Change of approval markings from UR and CSA to the combined cURus on the product socket.

Product Change Notification					PCN 6765		D10-039-936
owner	creation date	release date	released by	change order no	rev	page	
huberth	24.09.2019	01.10.2019	limachcl	2018409	A	1 of 1

3 Detailed description of change

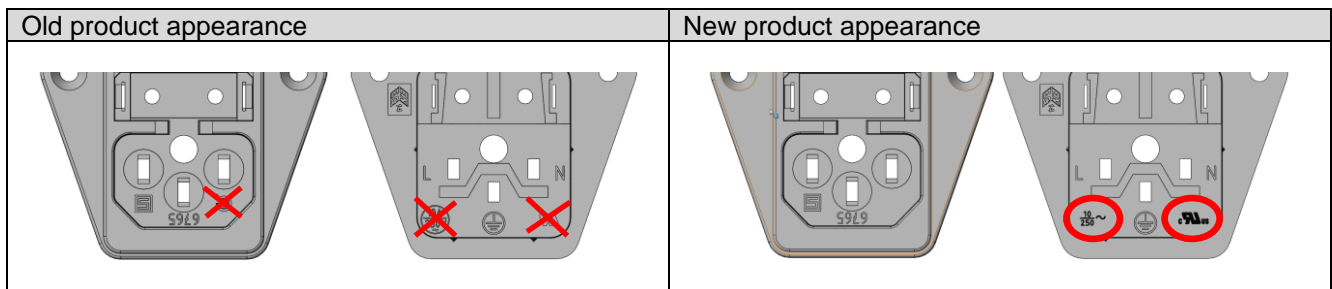
Form	Yes	Socket new with cURus approval marking
Fit	No	-
Function	No	-
Manufacturing	No	-
Label	No	-
Packaging	No	-
